Tylerville Public Hearing Comments and Correspondence and Responses

Public Hearing on Draft Water Supply Alternatives Evaluation Responses to Comments and Correspondence Received

Comments received at Public Hearing, Haddam Fire House, June 21, 2017:

GIS Map for Community Well Option

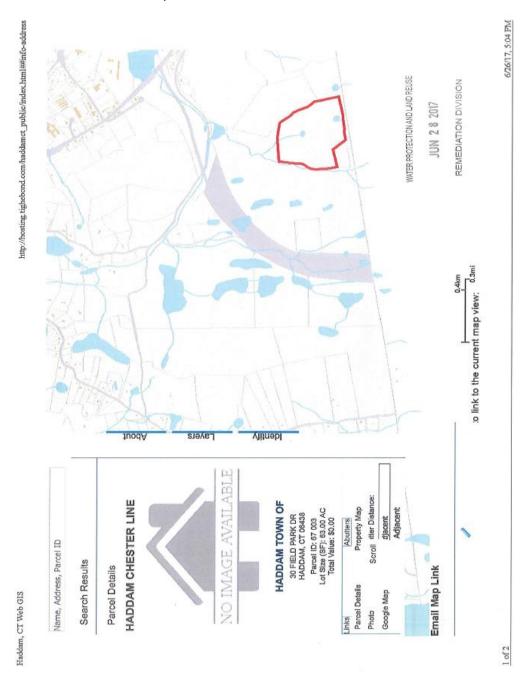
This is one of the weakest parts of the report. The consultants did not even bother to investigate this alternative thoroughly and just copied and pasted what was in the Weston and Sampson Engineers, Inc. (WSE) 1999 report.

That 1999 report only looked at one potential property for a local supply of water, ignoring the advice of resident and Wesleyan Geology Professor Jelle deBoer at the time regarding the possibility of locating those wells upgradient of water running towards Tylerville, namely the west side of RT 154. (Sadly Dr. deBoer passed away in 2016).

The state owns most of the land surrounding RT 82 connector in that area, which we would think would help facilitate a local water source. But what is even more troubling in this report, the consultant statement on page 3.2: "there is no suitable land under the ownership or direct control of the Town of Haddam" is false. Indeed the Town of Haddam owns about 63 acres of open space land west of 154 and South of RT 82 connector. Close to the Chester border and about a mile from the intersection of 154 with 82 (see attached PDF with GIS map with lot 67 - 003 in red). The consultants owe the residents to investigate this possibility more thoroughly with specific detailed costs and estimates rather than simply updating the unlikely scenario of 1999.

I forgot to send this GIS map with my letter. Could you please add this as well as my description below to the record? This is for my comment on the community well supply option

The area in red is the 63 acres owned by the town of Haddam parcel ID 67 003

It is abutted by State of Connecticut lots 65 016 2A (39 acres) and lot 64 008 (260+acres) up to RT 82 connector. Thank you

- 2. The alternatives presented within the Report were evaluated fairly and without bias to a predetermined selection. The development of a community groundwater supply is a complex and time consuming alternative. In addition, as presented in the Report, identification of a groundwater source capable of meeting demand and quality requirements is highly uncertain. The parcel owned by the Town of Haddam that is referenced in the comment is protected open space located in an upland area that is not readily accessible (no nearby roads or infrastructure). The overburden in this area is mapped as thin till deposits; therefore, bedrock wells would be the water supply source. Typically, stratified drift and sand and gravel deposits found in river valleys are preferred for locating community water supply wells based on high water yields. The water yield in bedrock wells is uncertain, as is the water quality. As noted in the Report, area bedrock contains naturally occurring arsenic, which may adversely impact water quality in a new bedrock well and require expensive treatment to remove. Further, Connecticut Water Company holds the exclusive services rights to the Study Area. As such, any new water supply system developed to serve Tylerville would ultimately be managed by Connecticut Water Company. Leveraging Connecticut Water Company's existing water supply and infrastructure in the Town of Chester with available water quantity of known quality is the prudent and economical alternative given the unique characteristics of the current conditions.
